City of Rockport

CITY COUNCIL REGULAR MEETING AGENDA

18. Consider the approval of Construction Change Directive #4 related to the new City Hall project

Consider the approval of Construction Change Directive #5 with Teal Construction related to the new City Hall project (cost pending)

No.	DATE	DESCRIPTION
1	02.07.2023	RFI #82.1
2	08.09.2024	RFI #185

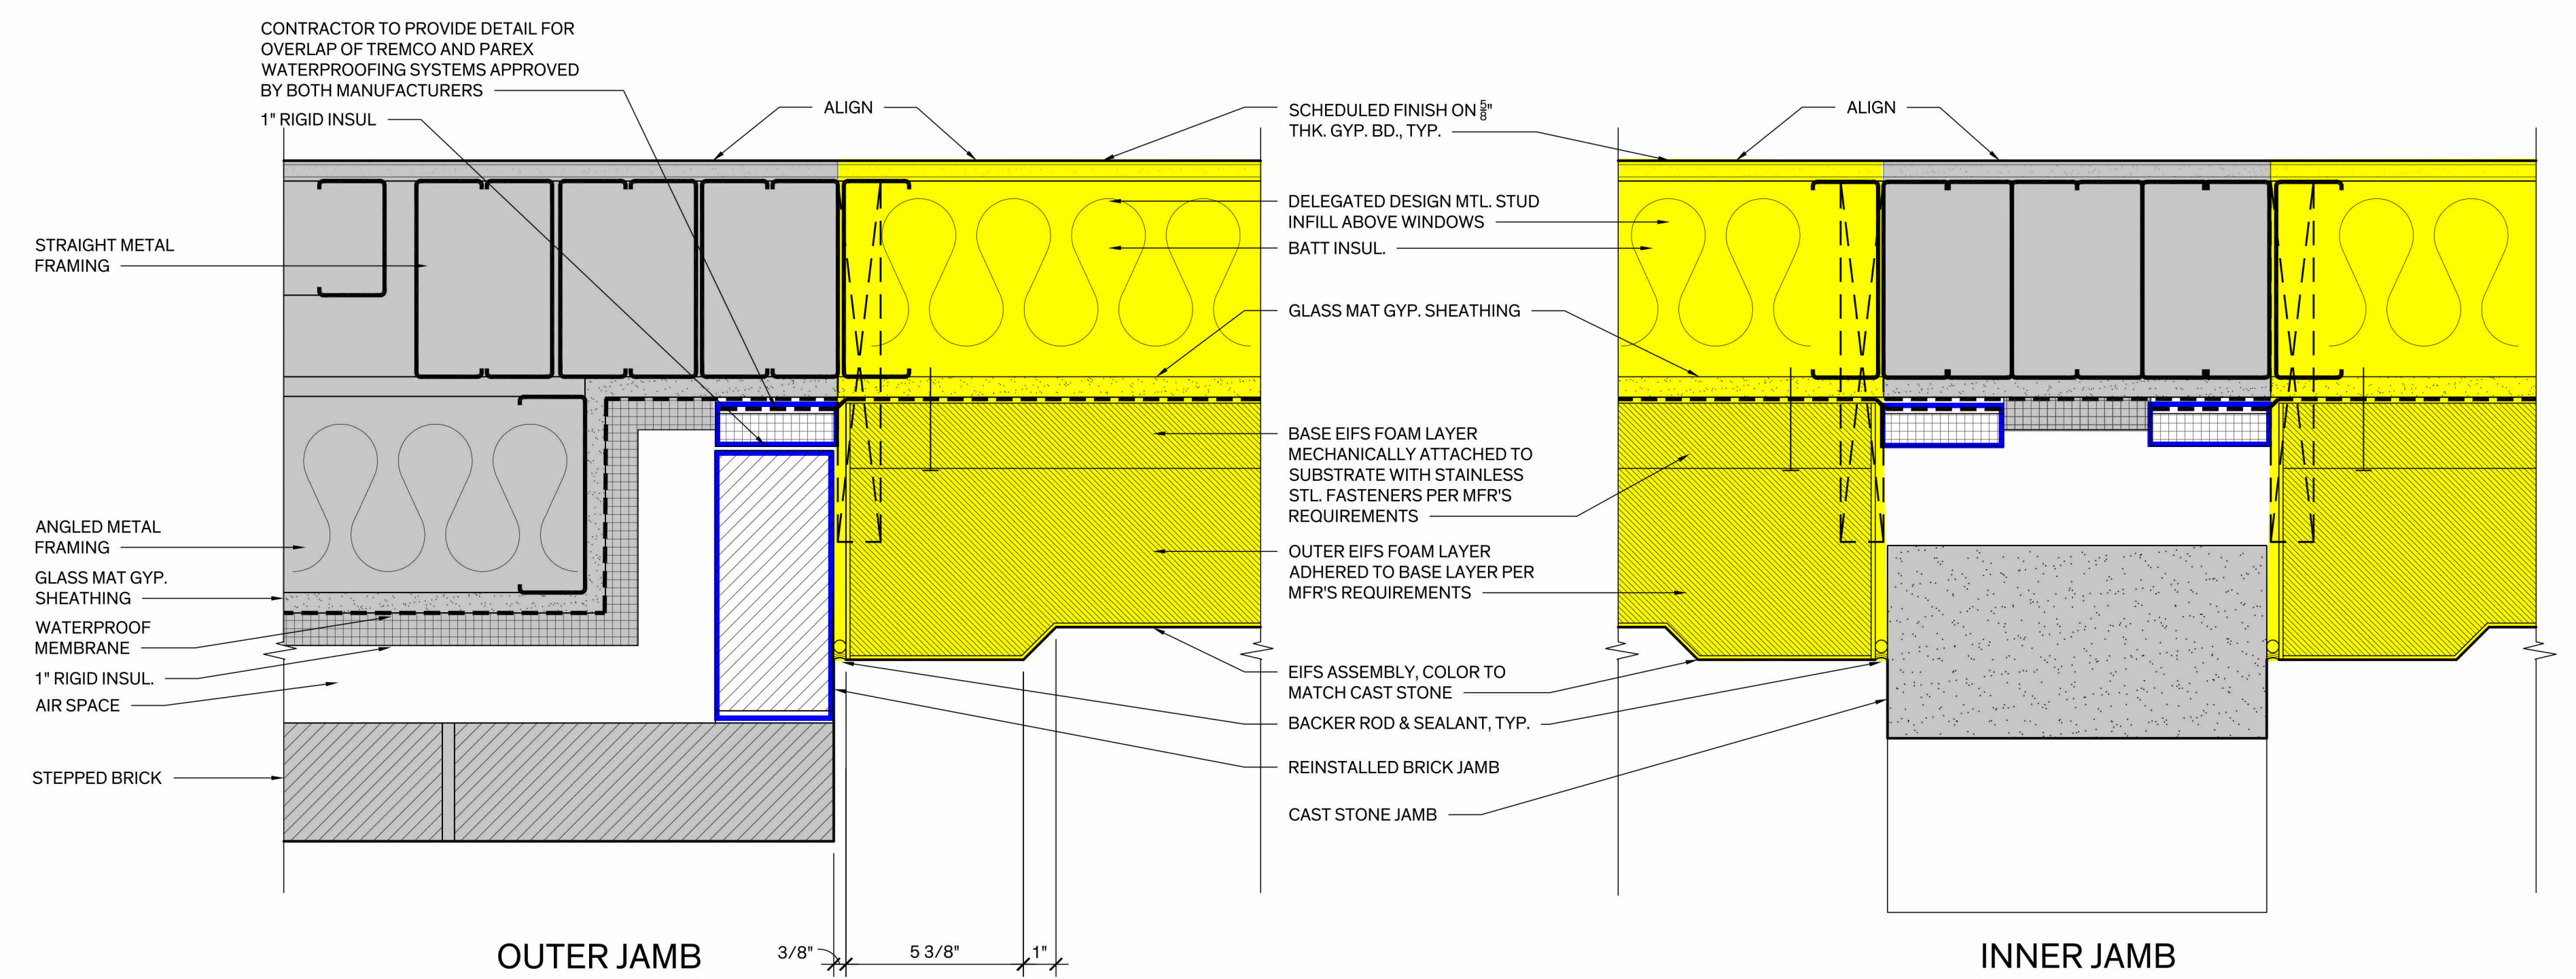
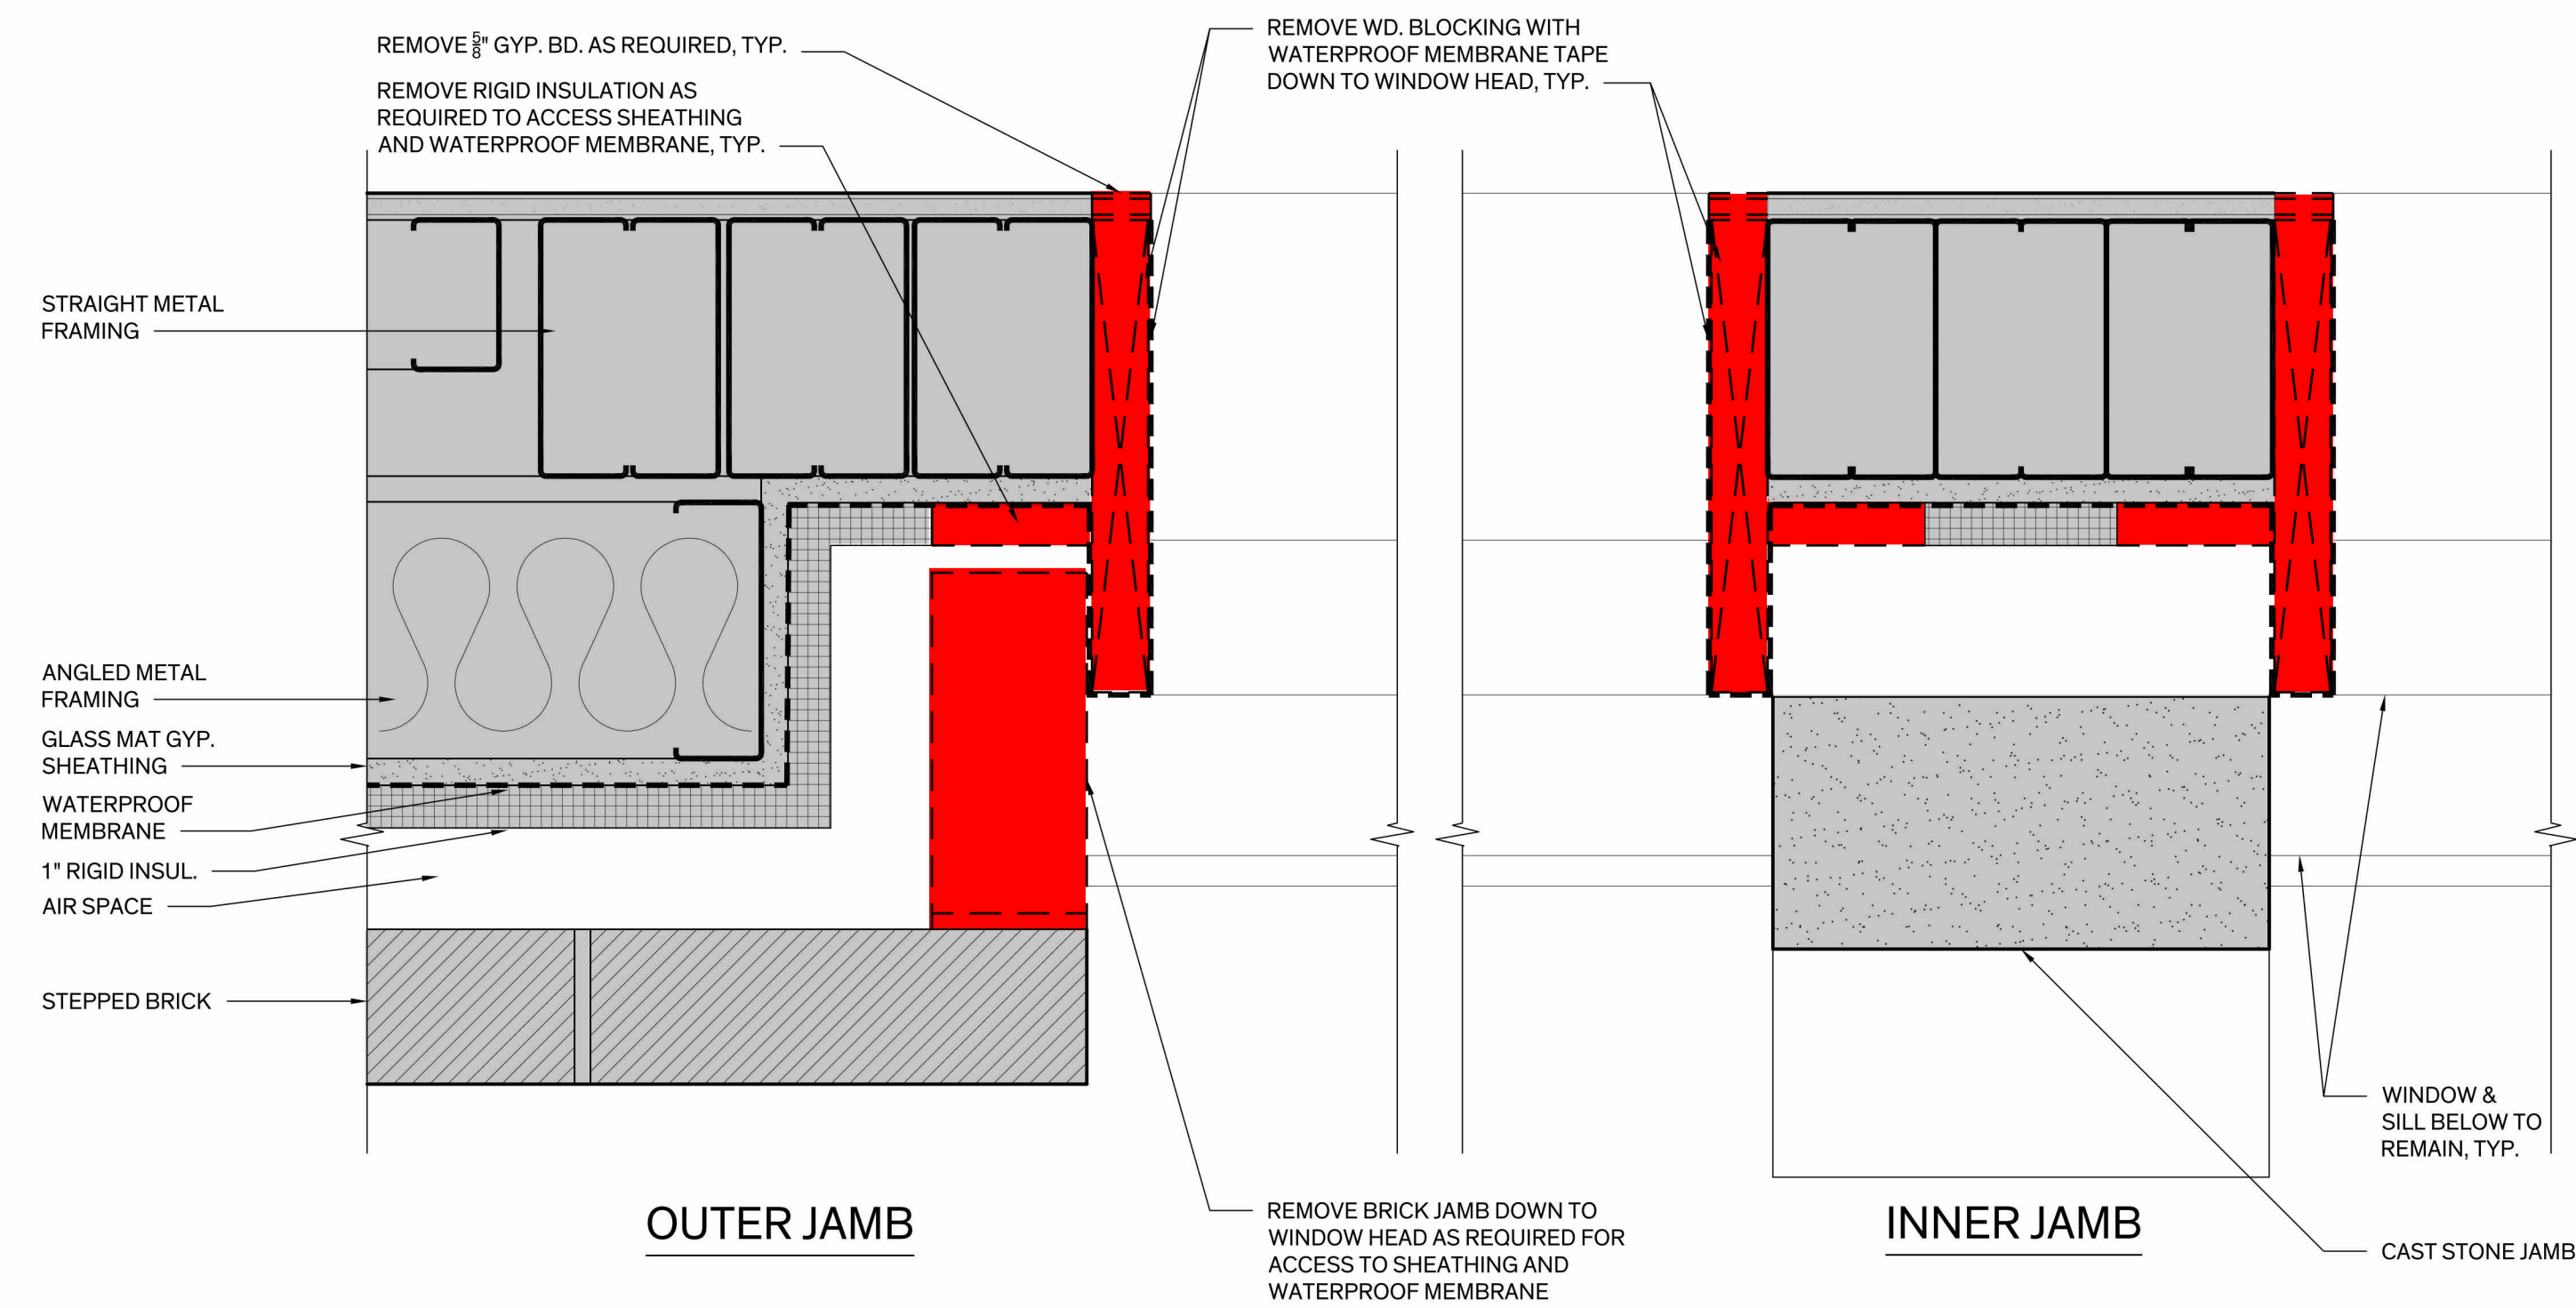
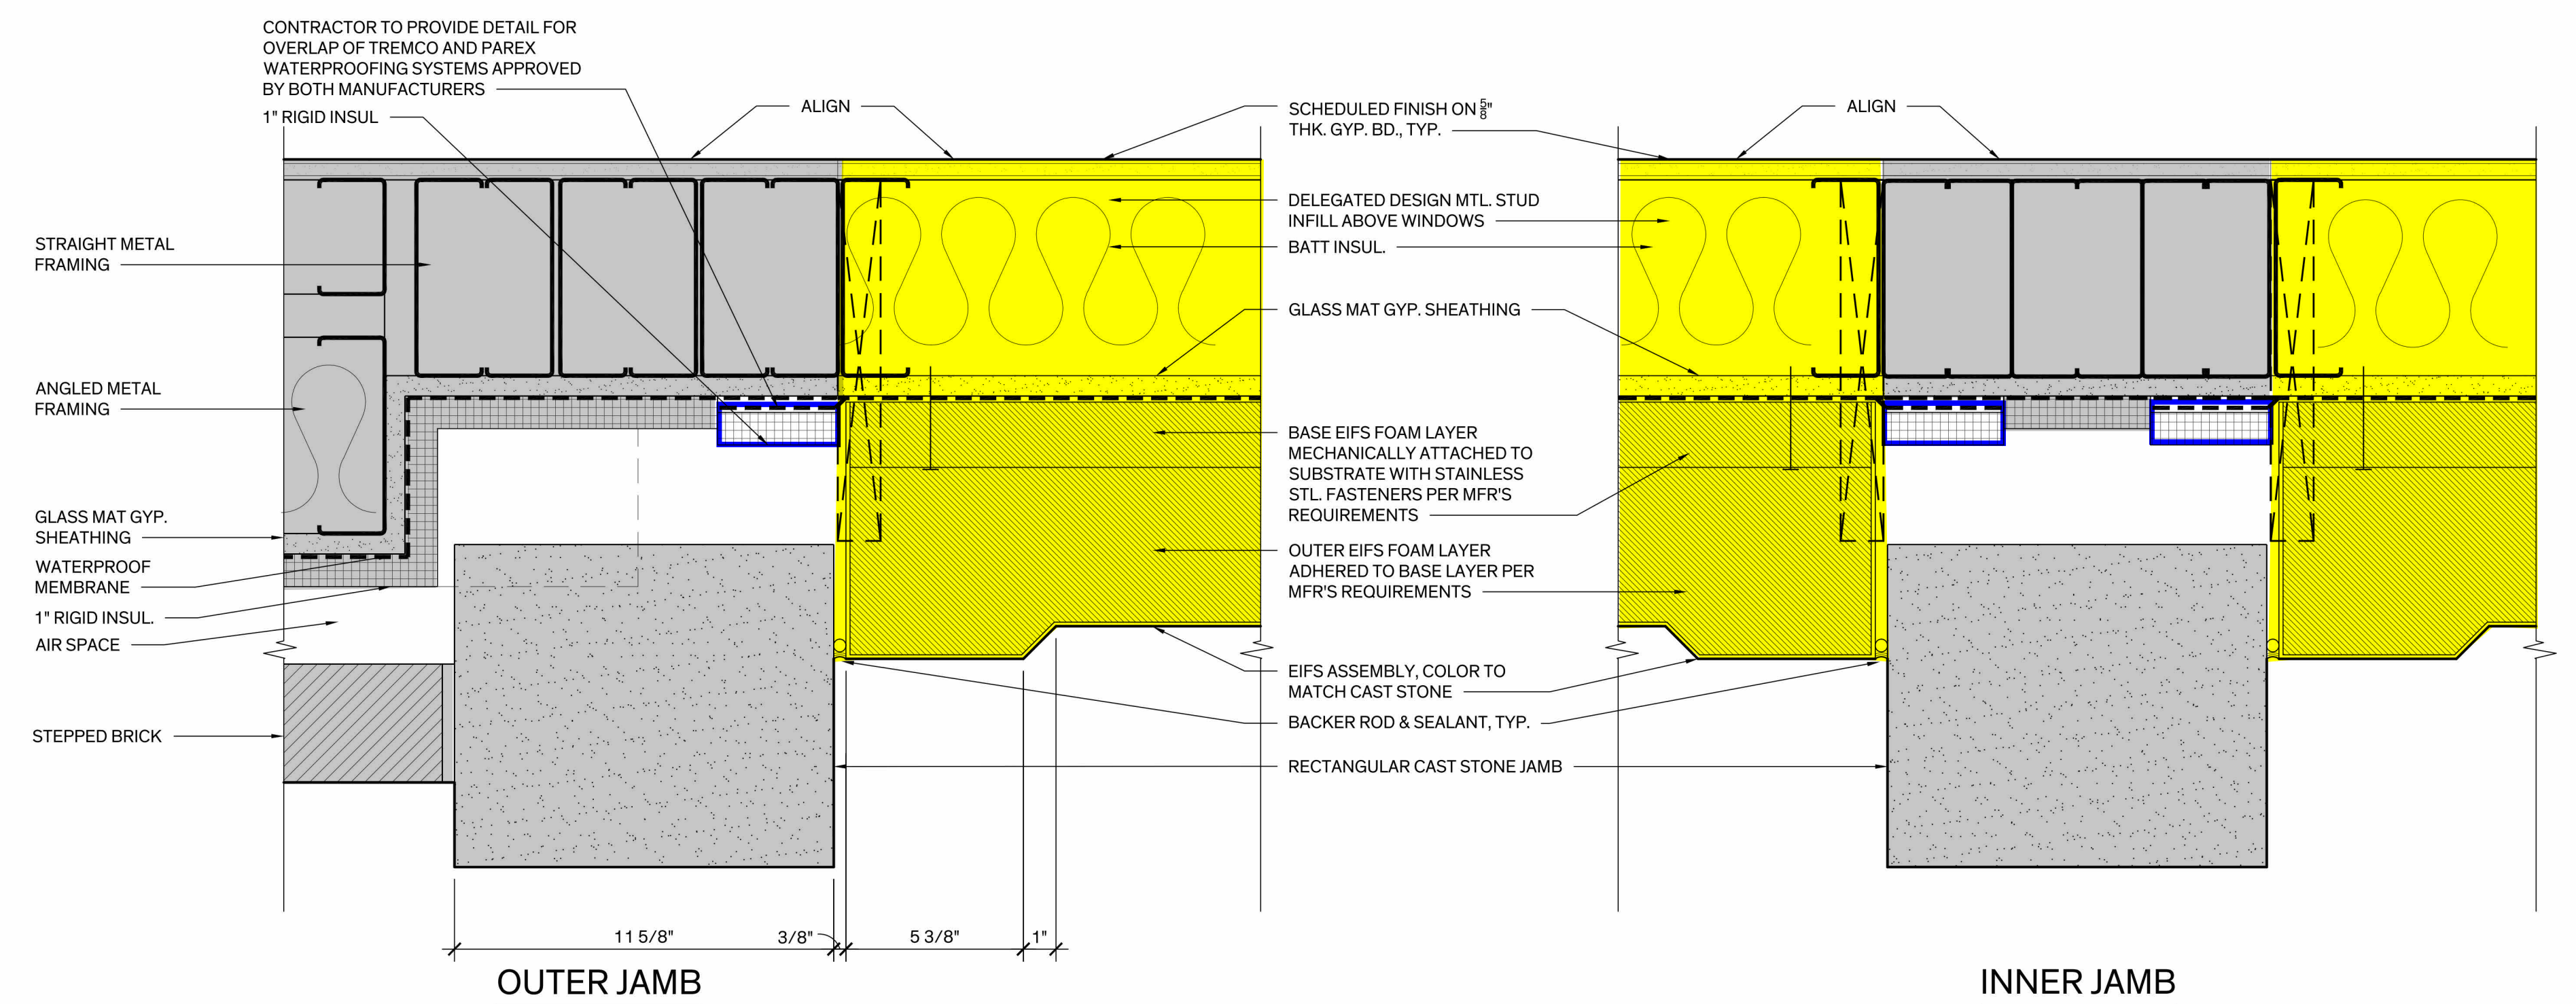
REMOVE		INFILL REQUIRED AT EIFS PANELS
	AS-BUILT TO REMAIN		REINSTALL REMOVED COMPONENTS

Provide EIFS infill with recessed panel detailing within arched openings above tower windows. Refer to attached revised SK-3A, SK-3B, SK-3C, SK-3D, and new SK-3E.
